Product Notice

PACE 1003

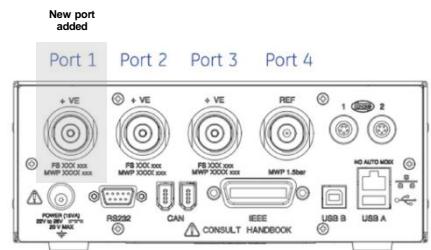
Mechanical changes have been made that has added an additional port to the back panel of the PACE 1003

Whilst the total limit of the number of sensors that can be accommodated in a PACE 1003 remains at 3, this change now makes it possible to offer 3 gauge sensors as an option, due to having the additional port that can be used as a reference for the gauge sensors.
